Brooklyn Inland Wetlands Commission
Special Meeting Agenda
Tuesday, August 8, 2023
Zoom and In-Person Meeting
Community Center
31 Tiffany Street Upper Level
6:00 p.m.

RE: **Special Permit Modification
Townsend Development Associates, LLC
SP 15-006**

Below is an itemized response to the July 5, 2023 and July 10, 2023 Review Comments received from Northeastern Connecticut Council of Governments. For clarity original comments are in normal text and CHA responses are in **Bold**.

July 5, 2023 - Engineering Site Plan & Drainage Report Review

Drawing No. 2 (Sheet 1 of 1) – Improvement Location Plan

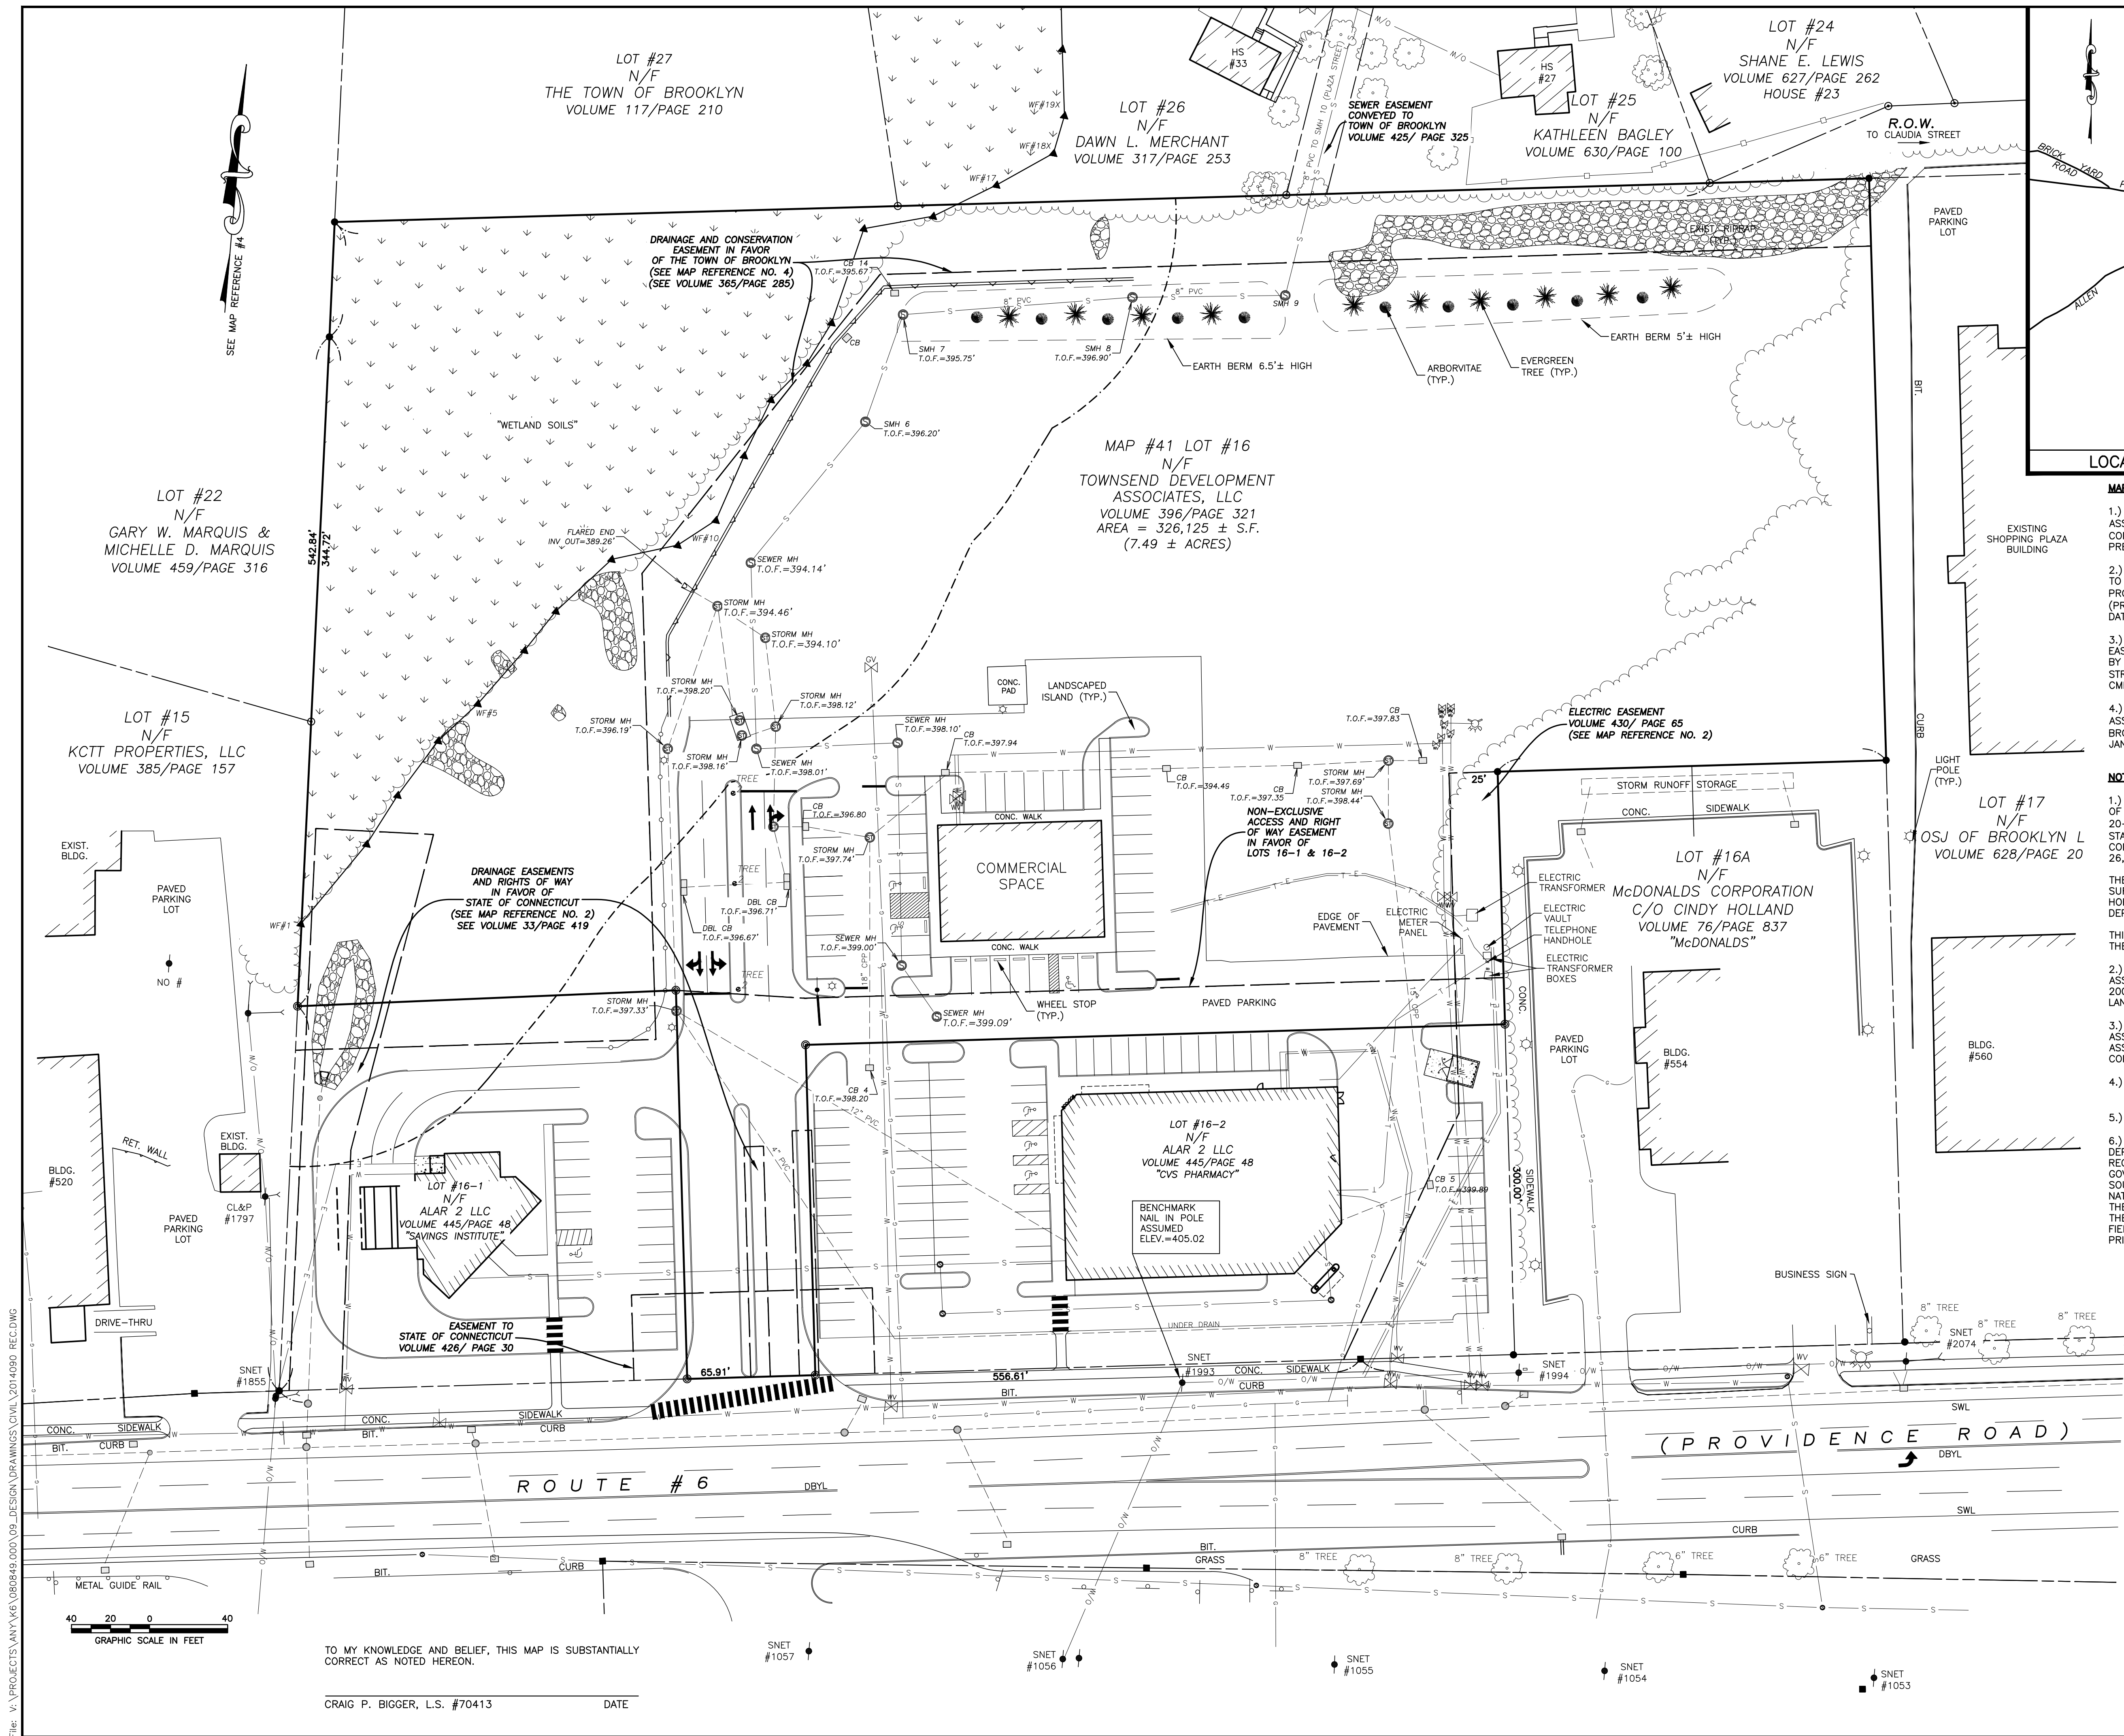
1. Are all of the abutting property owners shown on the 2017 plan present today? If not, a new large scale plan or drawing needs to be included in the plan set with current owners, similar to the "inset site installation drawing" included in Drawing No. 13.
Drawing 2 has been updated to revise the current Owners.

LAYOUT PLAN

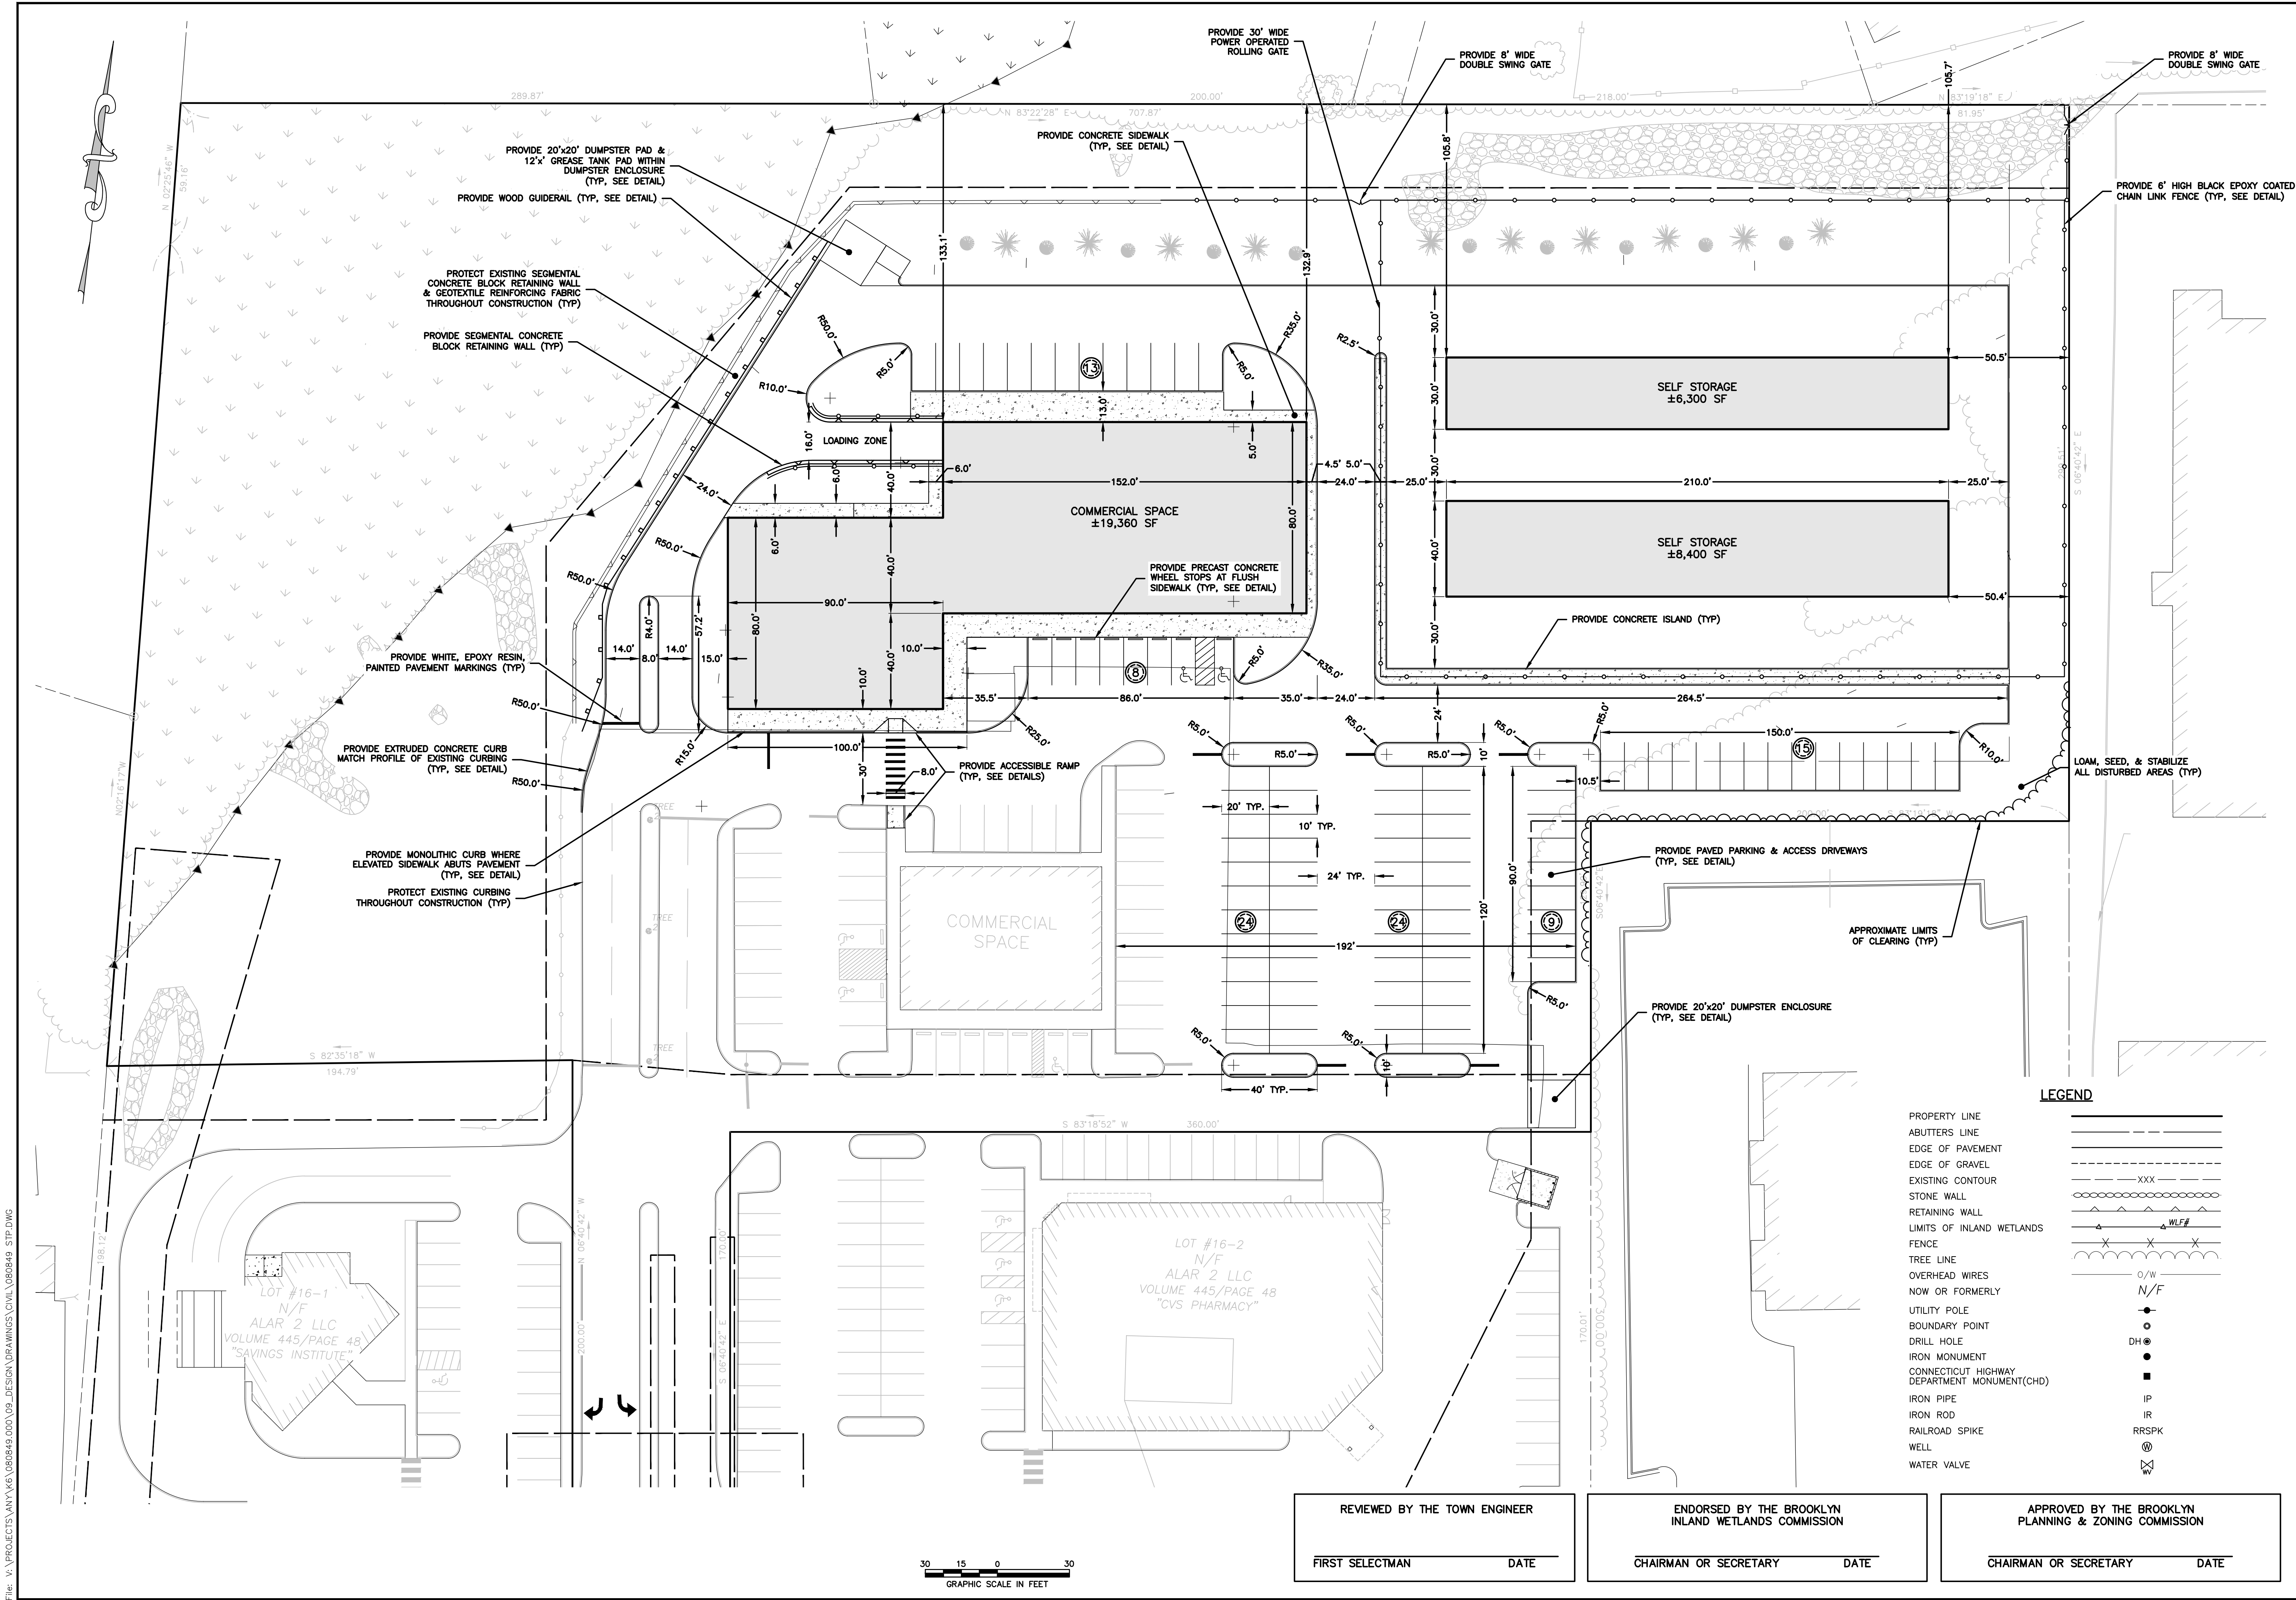
1. Not all sidewalks shown are dimensioned. All sidewalk widths need to be specified on the plan.
Additional dimensions have been added to the plan set.
2. If the sidewalk at the south end of the proposed crosswalk is not flush with the pavement, a sidewalk ramp will need to be constructed there and a construction detail provided — see Type 17 on CT DOT "Sheet 6 – Sidewalk Ramps."
A new sidewalk ramp and detail are now provided.
3. The layout plan is missing some dimensions for curb radii, tangents, aisle widths, loading zone width, etc. All dimensions need to be shown to be able to call this a true layout plan. Scaling dimensions off the plan where no dimensions are shown is unacceptable as this is prone to reading error and distortion in a paper printing process.
Additional dimensions have been added to the plan set.

4. The “Commercial Space” building footprint is missing dimensions; however, the “Self Storage” units do have dimensions shown. Add all dimensions to the commercial space.

5. The wood guard rail end treatments on the west side of the development need to be described on this plan or on the Construction Details plan.

6. If the wood guard rail is struck by a vehicle, has the impact to the segmental retaining wall adjacent to the posts been evaluated? The distance a post will be located from the back side of the wall needs to be shown in a construction detail. Furthermore, has the condition of the wall been inspected with respect to the development of this project and in consideration of the traffic (vibration) of heavy construction vehicles travelling close by?

Additional dimensions have been added to the plan set.

An end treatment detail has been added to Sheet 11 of the plan set.

On similar previous projects, a minimum separation of 3'-3" from the face of retaining wall to the back of the guardrail posts (±4' from face of wall to traffic face of guardrail) has been required by the wall designer/manufacturer to handle the potential impact loads. The location of the proposed guardrail has been moved to be 18-inches from face of curb to face of guardrail, providing at least 4' from face of existing retaining wall to face of proposed guardrail. Notes have been added to the wood guardrail detail to clarify this.
